# Service Bulletin

Bulletin No.: 24-NA-055

**Subject: Removable Sky Panel Creak Pop Snap Noise, Hot Interior Temps**

Brand:	Model:	Model Year:		VIN:		Engine:	Transmission:
		from	to	from	to		
GMC	Hummer EV Pickup	2023	2024				
	Hummer EV SUV	2024	2024

5832341

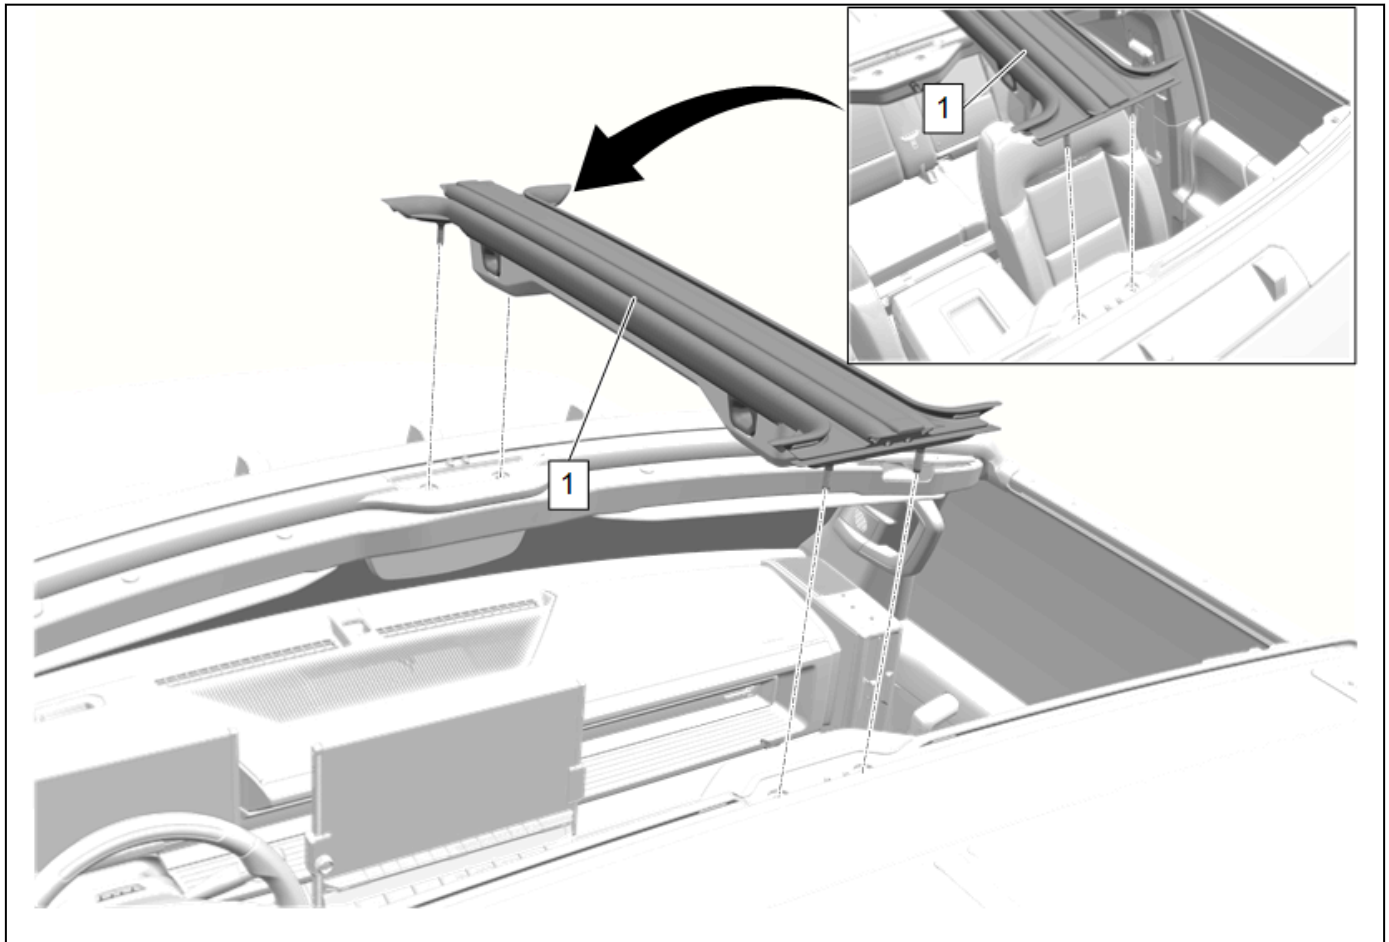
1. Remove the four nuts (1) from the Front I-Bar.

6425255

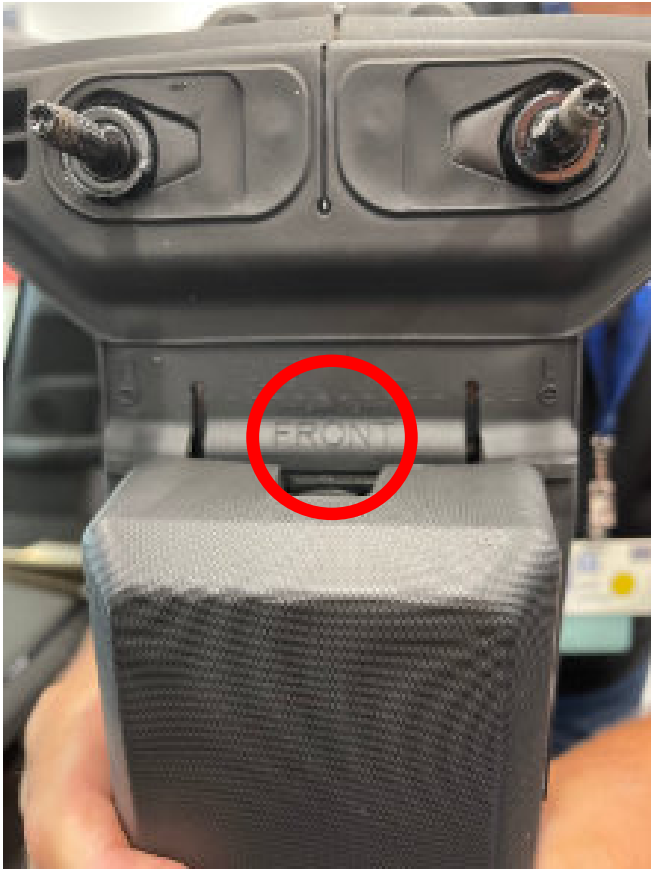
4. Remove the two trim panel push-pin retainers and remove the I-Bar panel cover.

6693889

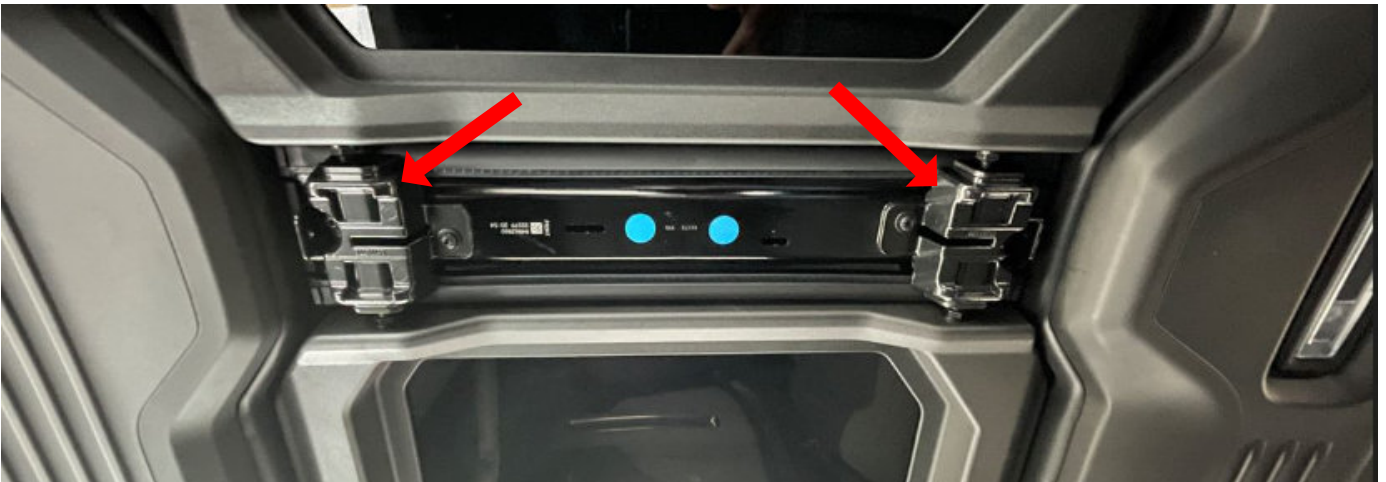
**FRONT** should point towards the front of the vehicle. If the rear I-Bar is reversed, follow SI DOC ID 5835570 to remove and re-install the rear I-Bar.

6430466

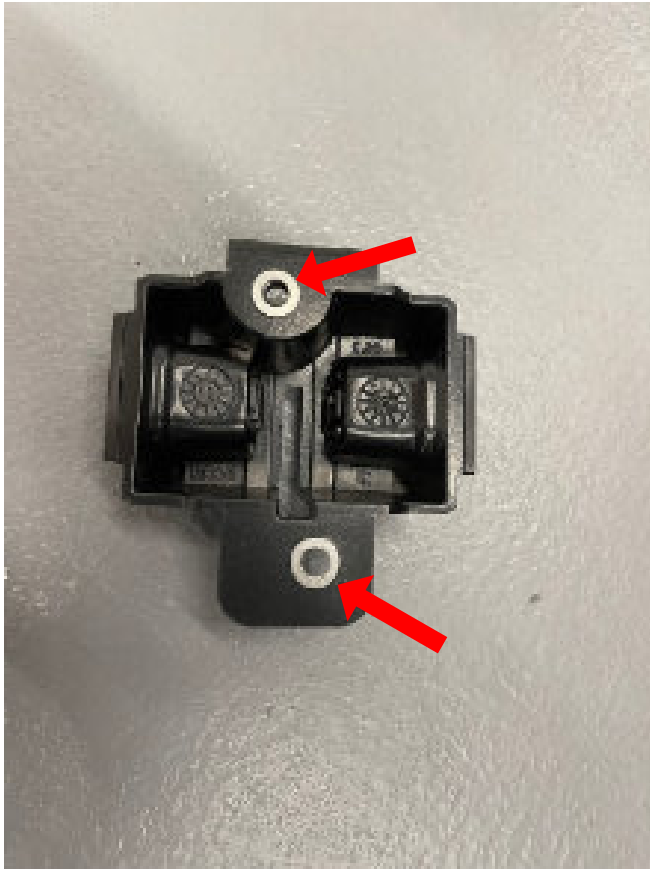
2. Remove both I-Bar pocket receivers.

3. Place a washer at each of the four bolt holes underneath the pocket receivers.
4. Reinstall the receivers to the I-Bar, torque to 9nm.
5. Reattach the rear I-Bar trim cover.
6. Use soapy water to clean the weather strips and then apply a very light application of AC Delco Super Lube to the weather strips.
